**Source:** Leece-Neville Heavy Duty Systems Division – Arcade, NY  
**Bulletin No:** TSB-1195 **Date:** February 2, 2022  
**Models:** 8MR  
**Subject:** 8MR to A1737, A1739, A1742

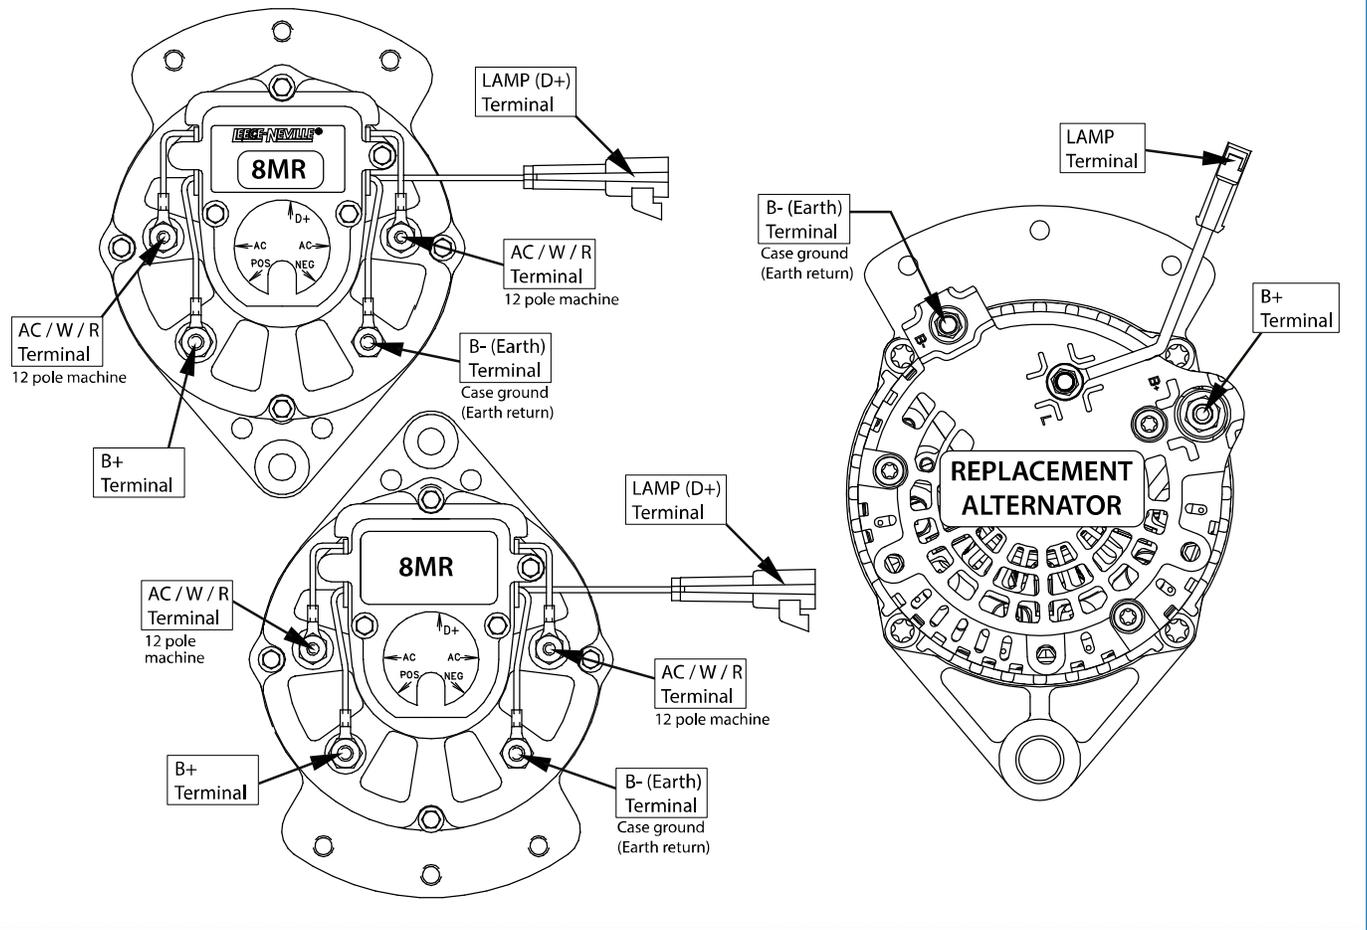
Alternator 8MR is discontinued and replaced by A17xx range of refrigeration alternators.  
 8MR2316L, 8MR2326L, 110-606, 110-646 (Earth return) = A1739B  
 8MR2313U, 8MR2325U, 110-608, 110-643 (Insulated return) = A1742B

These alternators are direct mechanical (drop-in) replacements; however, they are **case ground (earth return)** machines.

**Note:** A1737, A1739 and A1742 have internal cooling fans. External fan used on 8MR is not needed.

This document will help identify terminal location variances.  
 For detailed wiring diagram of the A1737, A1739, A1742 see TWB-0065.
